Docket Item # 7 & 8
BAR CASE #2013-0124/141

BAR Meeting
May 15, 2013

ISSUE: Permit to Demolish/Capsulate and Certificate of Appropriateness for Alterations/Signage

LOCATION: 605 Franklin Street

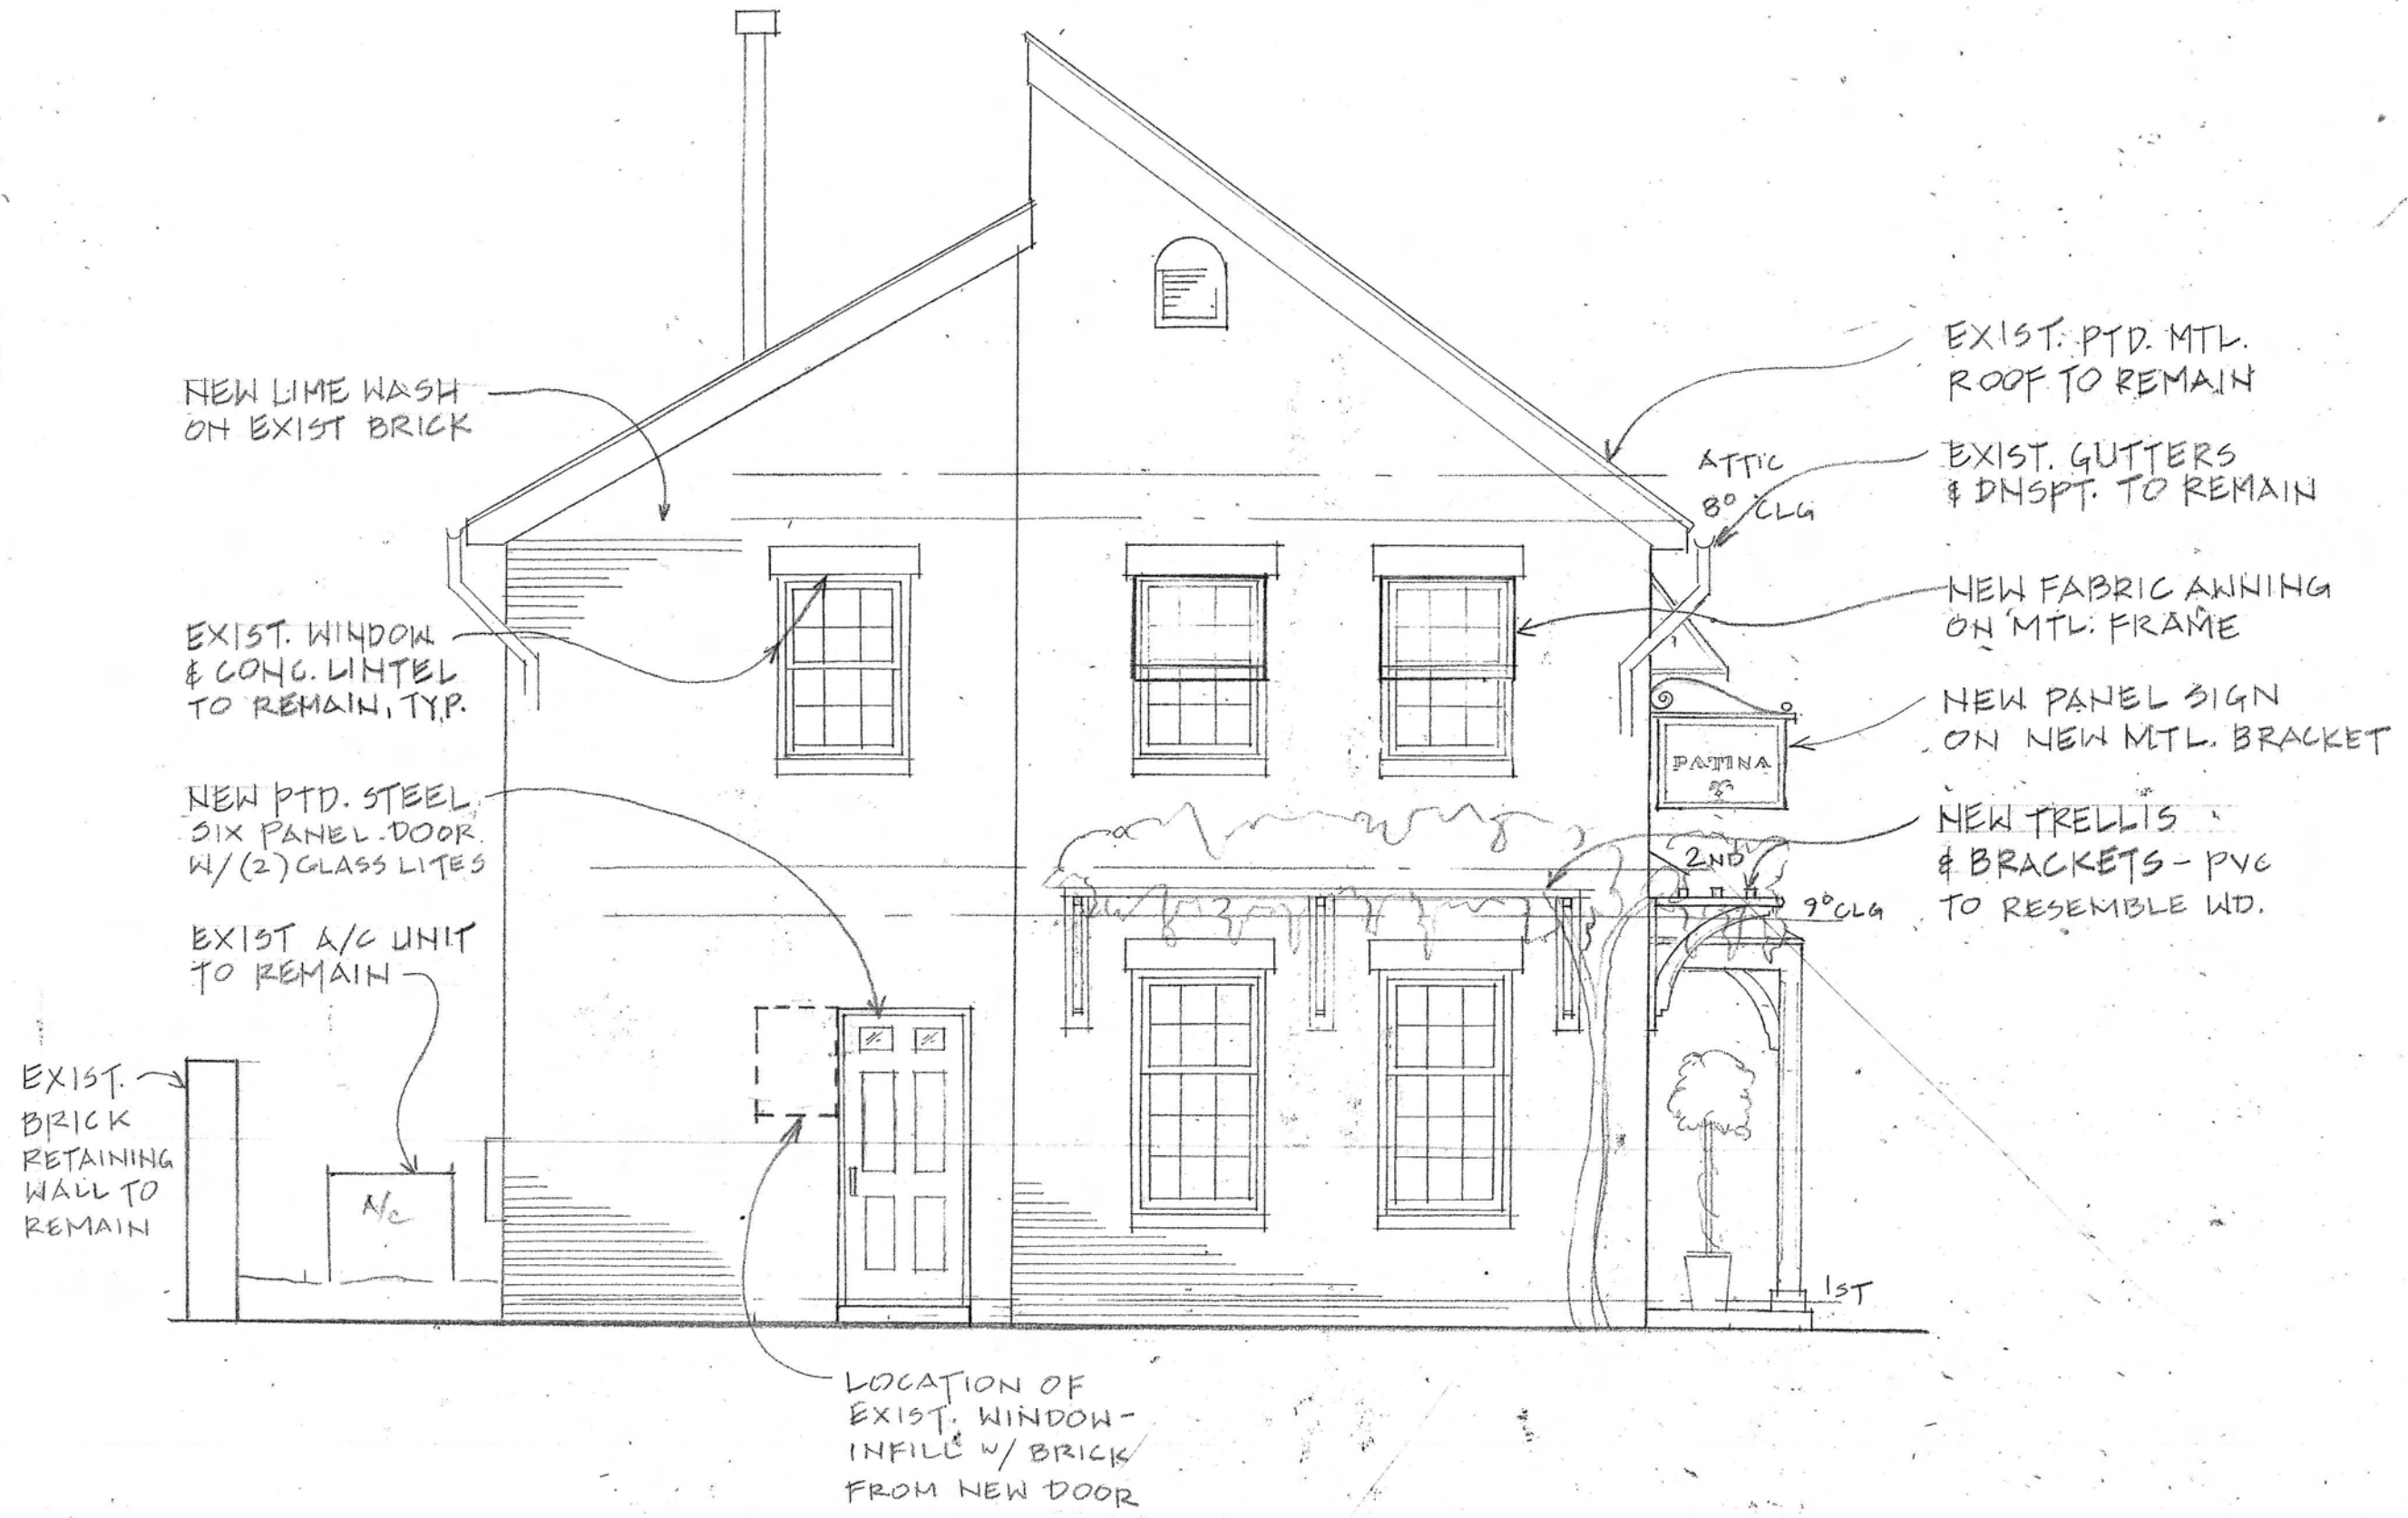
Staff recommends approval of the Permit to Demolish/Capsulate and Certificate of Appropriateness with the following conditions:

1. That the new wood gate is painted or stained.
2. That the color and material of the fabric awnings are submitted to BAR staff for review and approval prior to issuance of the Building Permit.
3. That the proposed SDL painted wood windows will comply with the BAR's adopted Window Policy.

PROPOSED SOUTH ELEVATION
 1/4" = 1'-0"

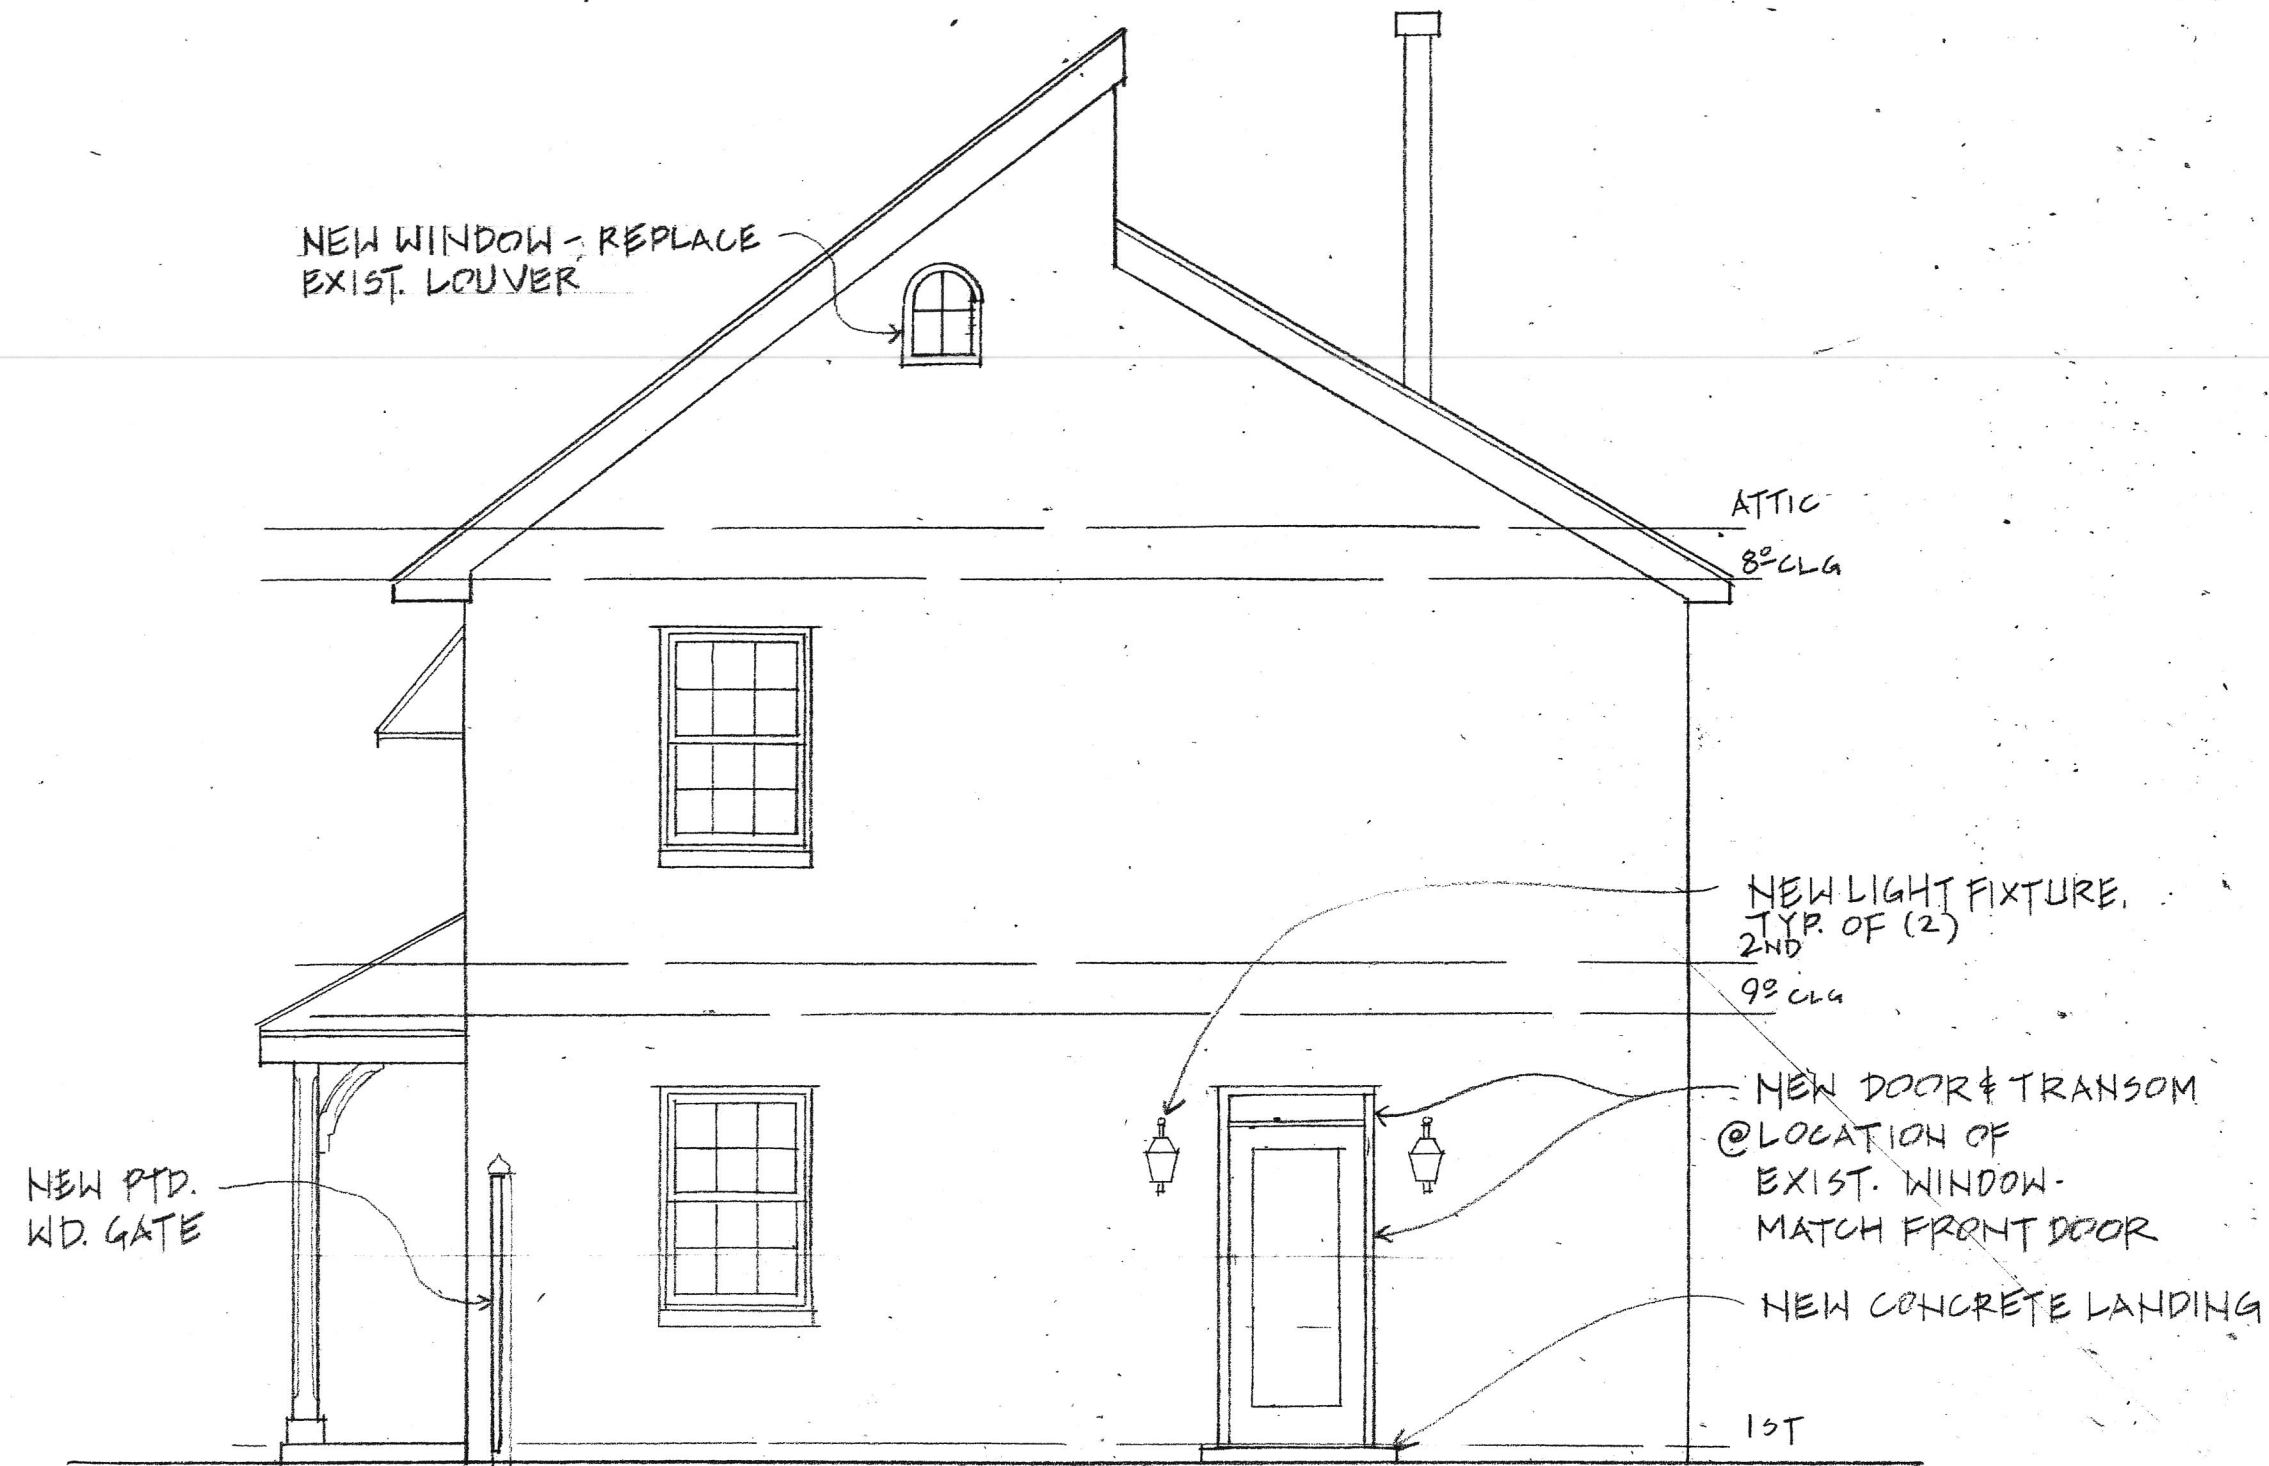
- Demolition of approx. 21 sq. ft. of wall area, including an existing window, to install a painted steel, six-panel door with glazed top panels.

- Install a new bracketed, PVC trellis above the first floor windows.
- Install fabric awnings above second floor windows on the main massing.
- Install a painted steel, six-panel door with glazed top panels.
- Install a wall, mounted, lantern-style, light fixture with motion-sensor to the left of the new entry door.
- Remove and replace the existing third floor louver with an arched, four-light SDL, painted wood window.

PROPOSED EAST ELEVATION

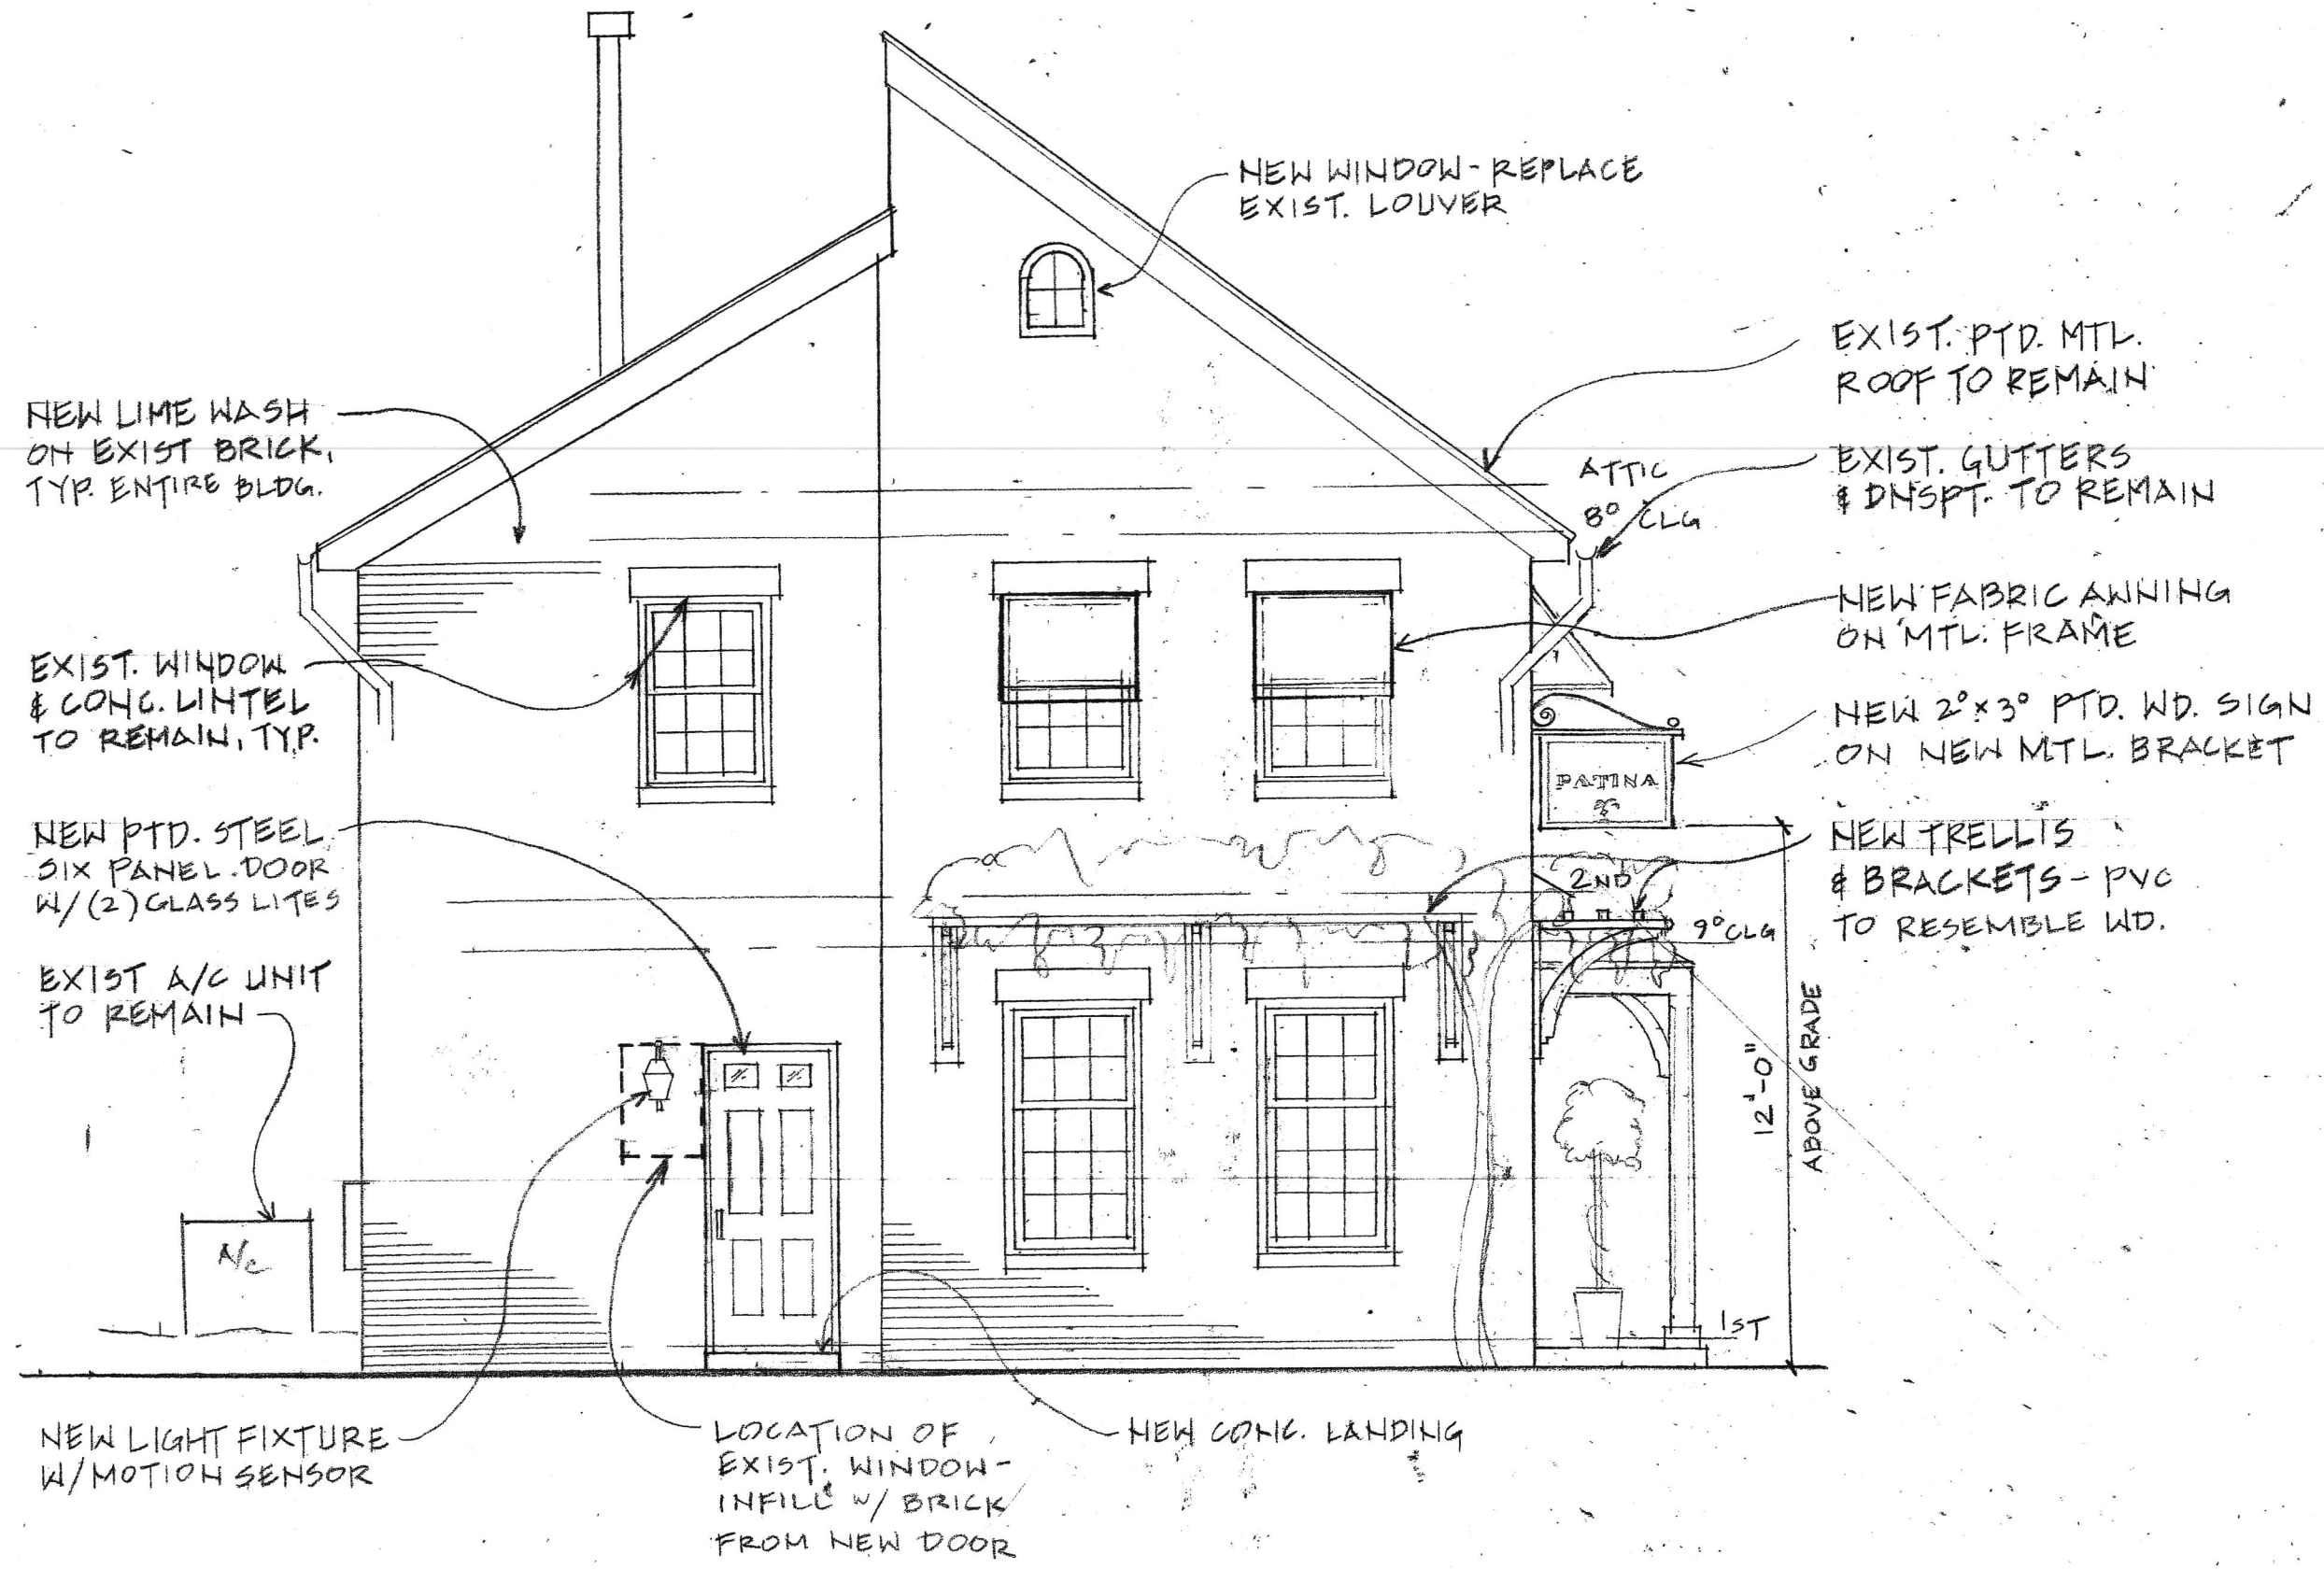
- Demolition of approx. 8 sq. ft. of wall area below existing window to install a new, a new, painted wood, single-light entry door with single-light transom.

- Remove and replace the existing third floor louver with an arched, four-light SDL, painted wood window.
- Install a new, painted wood, single-light entry door with single-light transom.
- Install two (2) wall, mounted, lantern-style, light fixtures to flank entry door.
